REPORT TO: COUNCIL ASSESSMENT PANEL

DATE: 24 APRIL 2019

SUBJECT: APPEAL ITEM – 110/00614/18 CONSTRUCT TWO SEMI-DETACHED DWELLINGS, INCORPORATING A THREE STOREY DWELLING AND A TWO STOREY DWELLING, WITH THE NORTHERN DWELLING HAVING AN UNDER CROFT GARAGE AND THIRD LEVEL AT 34 AND 34A ADELPHI TERRACE GLENELG NORTH

Section Plan showing stepped retaining wall

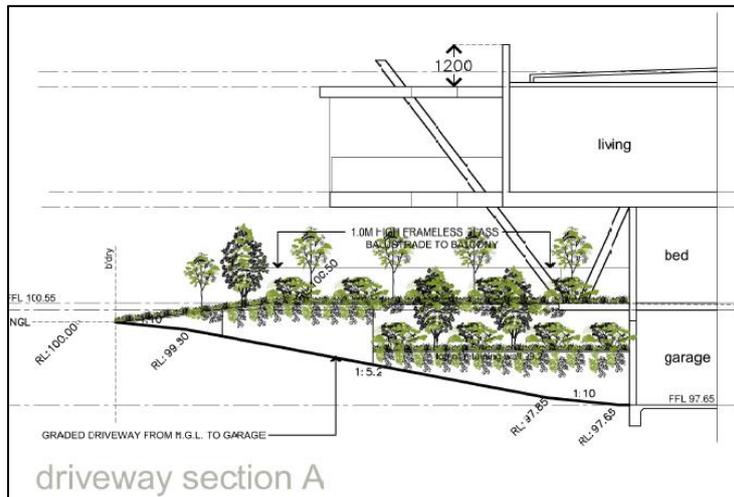
The proposed changes to the undercroft driveway are considered to be an improvement in that the visual impact of the retaining wall to the streetscape will be reduced and softened with the inclusion of more landscaping. The plans now include a section plan that demonstrates that the undercroft will have little visual impact to the streetscape given that the upper storey is cantilevered over the driveway. Whilst the proposal is still at odds with the relevant provisions of the Development Plan, the proposal is considered to be suitably designed to minimise any impacts.

- The retaining wall on the northern side of the undercroft driveway is now stepped to break up the visual mass of the wall, and also to allow landscaping to soften the appearance.

Floor plans of the original proposal on the left, and the amended proposal on the right.

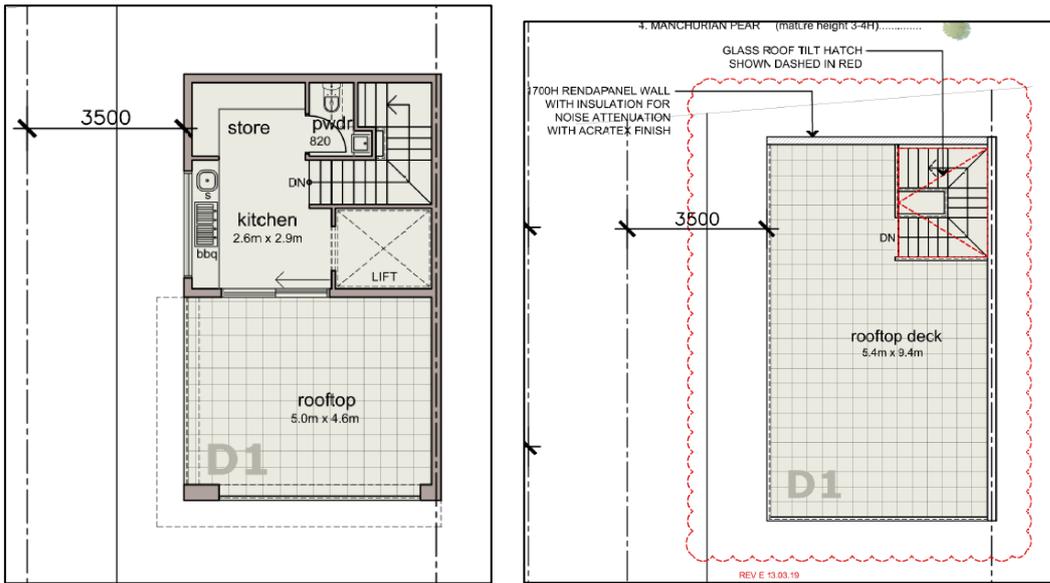
The most notable change to the proposal is the removal of the upper storey and replaced with an open roof top deck area. For comparison, below are the floor plans and elevations of both the original proposal and the compromise plans. The total floor area of the deck is the same as the previous proposal, but no longer includes the roof, but includes screening to the rear and sides to minimise noise and overlooking impacts to neighbours.

The amended plans are considered to be significantly less dominant than the previous proposal and has an appearance of a two storey dwelling as sought by in Principle of Development Control 8 of the Residential Zone. The amendments to the third level is considered to overall to be an improvement and is on balance more consistent with the requirements of the Development Plan for the Zone.

- The third level on the northern dwelling has now been amended to no longer include a roof or enclosed areas. The original proposal included a small kitchen and living area on the top level and was prominent to adjacent properties and the streetscape. The amended plan is for a roof top deck area that will not include a roof, but will be surrounded by a 1.7 metre high rendered panel to the rear, 1.7 metre high obscure glass walls to the sides, and a 1.2 metre balustrade to the front. The deck will be accessed via internal stairs, with the use of a glass hatch door, with a hydraulic opening. When the door is closed it will operate as a skylight to let more natural light into the upper level. Below is a sample image of the door.
